**DA NO:** DA-2023/281  
**ADDRESS:** 39 THE SCARP, CASTLECRAG NSW 2068.  
**PROPOSAL:** CONSTRUCTION OF A NEW DWELLING HOUSE, SECONDARY DWELLING, WORKSHOP, TREE REMOVAL, DETACHED CARPORT, CAR CROSSING LANDSCAPING AND ASSOCIATED WORKS.  
**RECOMMENDATION:** APPROVAL  
**ATTACHMENTS:**

**RESPONSIBLE OFFICER:** RITU SHANKAR – TEAM LEADER  
**AUTHOR:** OLIVIA NAVRATIL – ASSESSING OFFICER  
**REPORT DATE:** 26 NOVEMBER 2024  
**MEETING DATE FOR PUBLIC MEETING:** 03 DECEMBER 2024

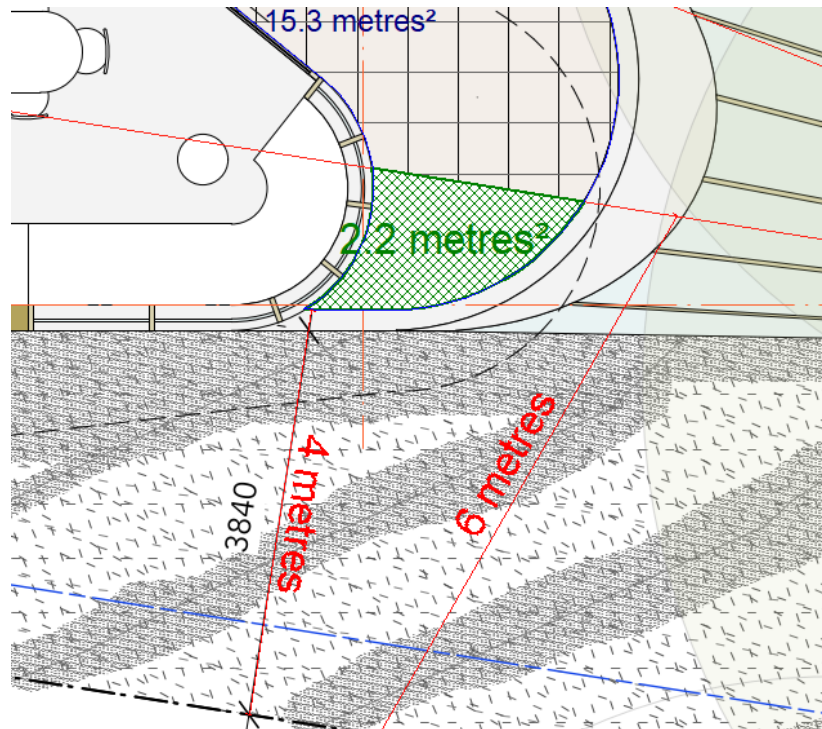
The west side boundary setback results in a maximum 522mm encroachment (57.2cm) at ground floor with 11.4sqm breaching the 1.5m side setback requirement.

The encroachment is acceptable on merit. In particular, the siting and orientation of the built form is sympathetic to the constraints of the site whereby the design is stepped to integrate with the landform rather than atop of the foreshore so as to enable intended residential development of the site and in a manner that is not considered to adversely impact the surrounding properties in obtaining views to Sailors Bay.

Note: Part of the ground floor balcony is the only balcony >2m above EGL.

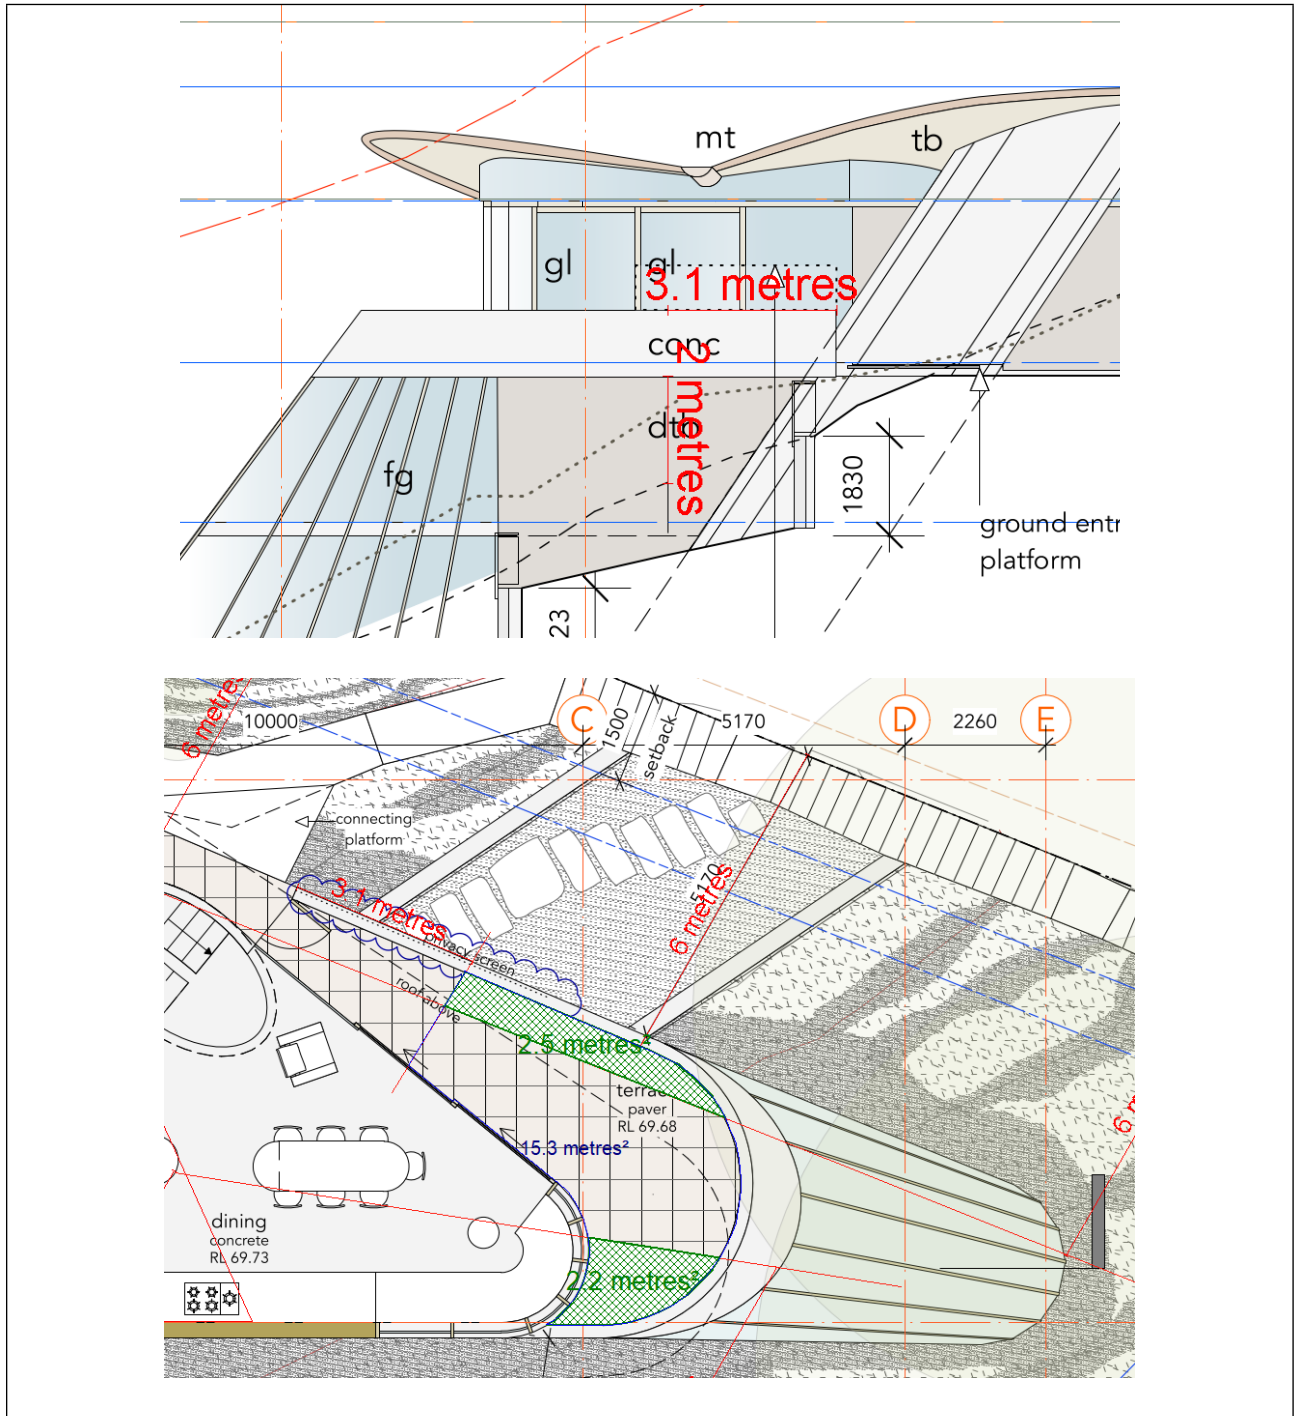
The ground floor entry platform and part of the balcony connecting to this platform (the part 3.1m deep from the platform) is <2m from EGL. See below extract for visual reference.

Note: visual reference of the steep topography and height of the detached carport/workshop from EGL.

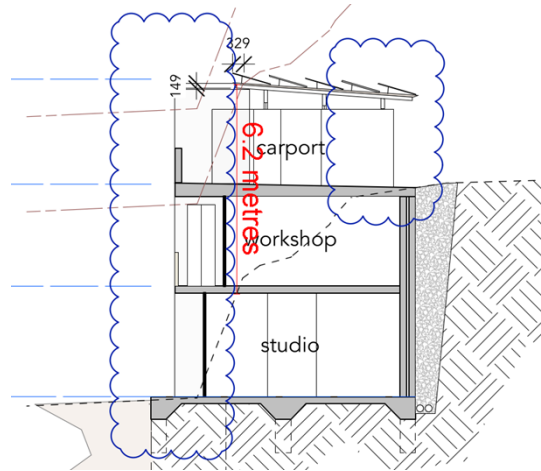
<p><b>Detached development</b></p>		<p><b>Detached development (carport and workshop):</b></p> <p>Height – 6.2m max above EGL. Acceptable on merit due to the topographical constraints of the property and achieving compliant vehicular accessing, noting that the topography contains a steep fall from the street. The departure is not considered to be unreasonable, noting additional earthworks to accommodate a compliant height/vehicular access would not ensure the preservation of the natural features of the site. See the below extract for visual reference.</p> <p>GFA – 43.9m<sup>2</sup> <i>Floor Area – 105.3m<sup>2</sup> (acceptable even when considered with the GFA control as the 5.3m<sup>2</sup> area would have minimal impact if it were removed to reach 100m<sup>2</sup>).</i></p> <p>Side setback – 900mm</p>	<p>Height above EGL: 4.5m Max GFA for detached development: 100sqm Side setback: lot width up to 18m – 900mm</p>	<p>Acceptable on merit</p>

Figure 1: Section demonstrating the exceedance of the building height control applying to the proposed dwelling (Source: Peter Stutchbury Architecture)

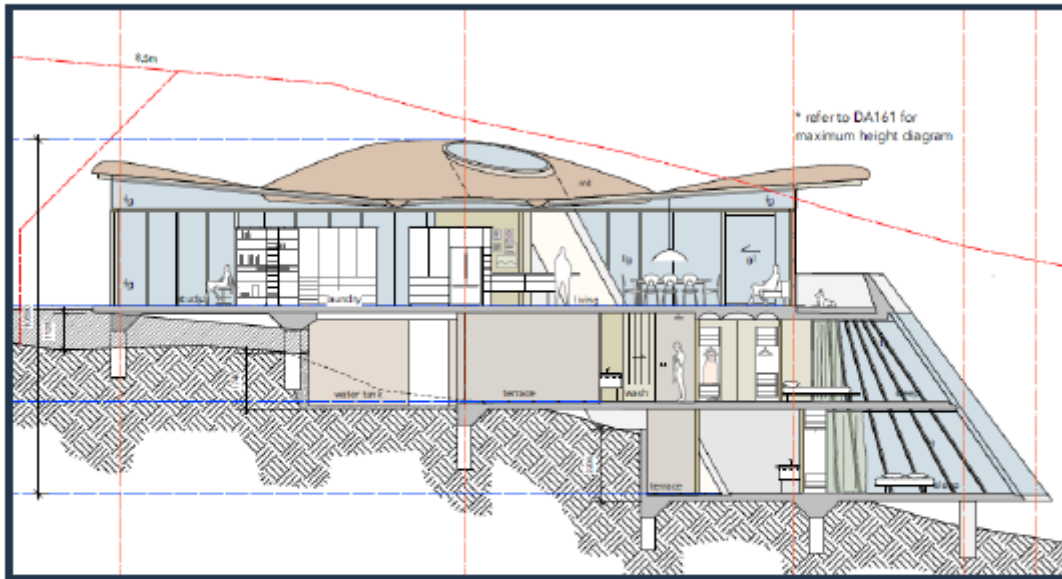
As set out above in the justification from Peter Stutchbury Architecture, the principal reason for the exceedance of the maximum building height limit is designing the development to best respond to the topography of the site. The proposed sections provided in Figures 1 below demonstrate the sloping topography of the site and the minor exceedance of the building height controls.

In light of the prevalent form of development in the area where elevated and projecting balconies can be found, the contravention is considered to be minor given it relates to a minor and non-accessible portion of a roof that creates visual interest within the site. A full assessment of the proposed variations has been undertaken to demonstrate the development standard is unreasonable or unnecessary in this instance and there are sufficient environmental planning grounds to justify the contravention. Despite the proposal's proposed variation to the development height standard, the development is considered to represent a superior design outcome, as set out in this Clause 4.6 Variation Request document.
